ENERGYSOLUTIONS

DRC-2023-079036

Subject: Federal Cell Facility Application - Responses to Request for Information– DRC-2023-004939

Operational Period Modeling of Depleted Uranium Radionuclide Concentrations in Groundwater, Pond Water, Pond Biota, and Air, and Modeling of Radon Ground Surface Flux

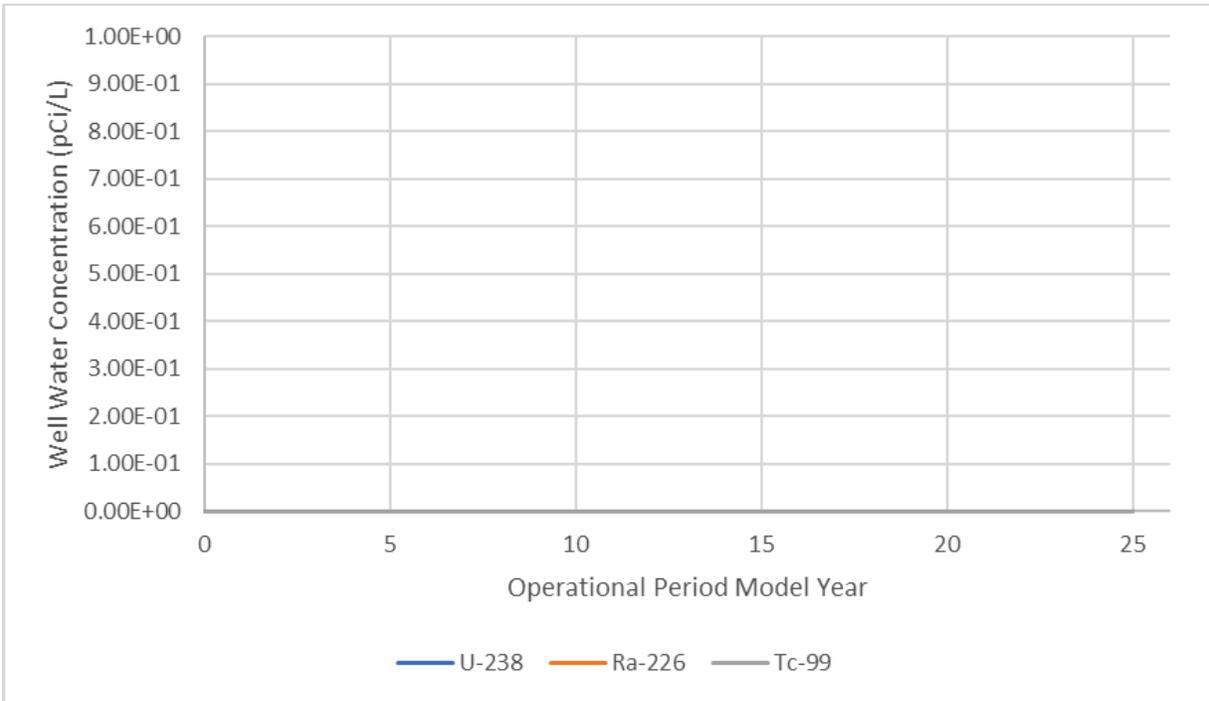
AB-17: The graph in the Groundwater section, on page 2, does not adequately display the relevant information discussed in the preceding text. It indicates that Tc-99 reaches groundwater at approximately year 35, and that the well Tc-99 concentration is approximately 0.006 pCi/L at 40 years; however, the x-axis (abscissa) does not reach these time periods, and the y-axis (ordinate) is excessively large. Please revise the graph to appropriately reflect all modeled data.

The anticipated duration of the operational period for the Federal Cell Facility is 20 years. Model results were generated and graphically displayed for a 25-year period. Because no radionuclides reach groundwater during the 25-year modeling timeframe the scale of the y-axis for well water concentrations was simply set as 0 to 1 pCi/L. The revised RESRAD-OFFSITE model applies the 1-ft clay layer (referred to as Liner Protective Cover in the facility design) that will be required above the 2-ft engineered clay liner, resulting in significantly longer times before any contaminants reach groundwater (assuming no cover exists and taking no credit for containers restricting release of radionuclides to groundwater).

Relevant text and the graph from Revision 2 of “Clive Operational Period RESRAD Analysis” dated December 2023 is reproduced below:

1. Well Water Radionuclide Concentrations. No breakthrough of any radionuclides at the well located 90 ft from the edge of the contaminated zone occurs within the operational period for any of the four open operational area cases evaluated. Even assuming no cover is placed on the disposed DU waste, and taking no credit for containerization, breakthrough of Tc-99 at the well does not occur until model year 200 in the RESRAD-OFFSITE evaluation. Longer-term modeling of releases to groundwater from the closed disposal cell is the subject of the DU PA.
